TECHNICAL BULLETIN

[Issue No.] GOT-A-0081-A

[Title] Change in the GOT2000 Series Rating Plate Associated with Conformance to ANSI/ISA-12.12.01

[Relevant Models] GOT2000 Series (GT2712-STW□, GT2710-VTW□, GT2510-VTW□, GT2508-VTW□)

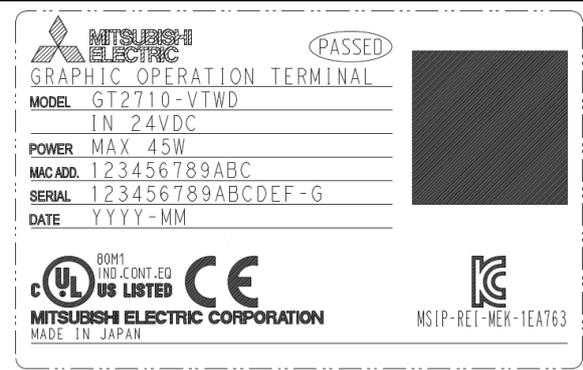
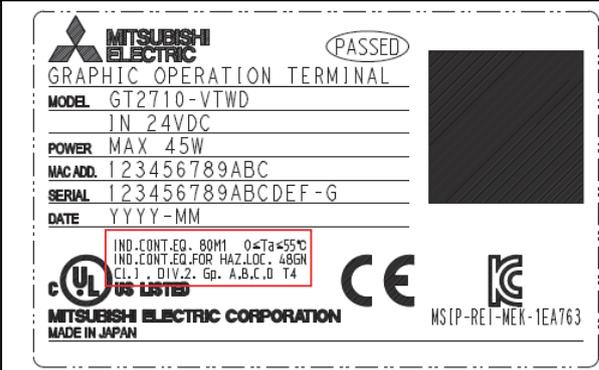
The indication on the rating plate has been changed. (Example: For GT2710-VTWD)

Before	After
 <p>The rating plate before the change shows the Mitsubishi Electric logo, 'PASSED' in a circle, 'GRAPHIC OPERATION TERMINAL', 'MODEL GT2710-VTWD', 'IN 24VDC', 'POWER MAX 45W', 'MAC ADD. 123456789ABC', 'SERIAL 123456789ABCDEF-G', 'DATE YYYY-MM', and certification marks for UL (80M1 IND. CONT. EQ. US LISTED), CE, and KC (MSIP-RET-MEX-1EA763). It is made in Japan.</p>	 <p>The rating plate after the change is identical to the 'Before' version but includes a red frame around the UL certification text: 'IND. CONT. EQ. 80M1 0 ≤ Ta ≤ 55°C', 'IND. CONT. EQ. FOR HAZ. LOC. 48GN', and 'CL. I, DIV. 2, Gp. A, B, C, D T4'. Below the image, the following text is provided: 'The following is indicated inside the red frame. IND. CONT. EQ. 80M1 0 ≤ Ta ≤ 55°C, IND. CONT. EQ. FOR HAZ. LOC. 48GN, Cl. I, DIV. 2, Gp. A, B, C, D T4 *1'.</p>

*1 T4A is indicated for the AC power supply model, and T4 is indicated for the DC power supply model.

■ Indication on rating plate (GOT rear face)

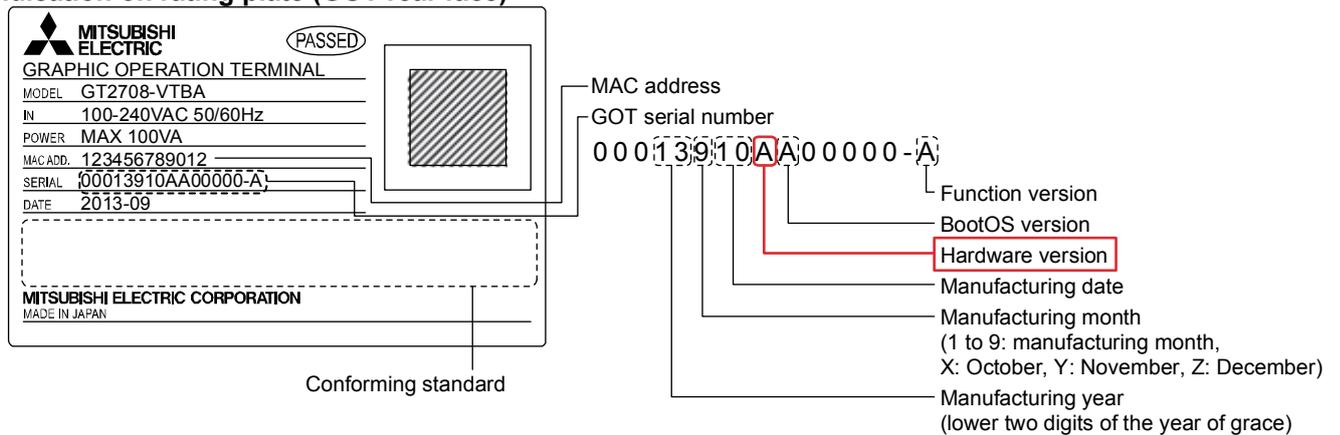
The new indication of the rating plate is applied to the following hardware version or later.

The following shows how to check the hardware version.
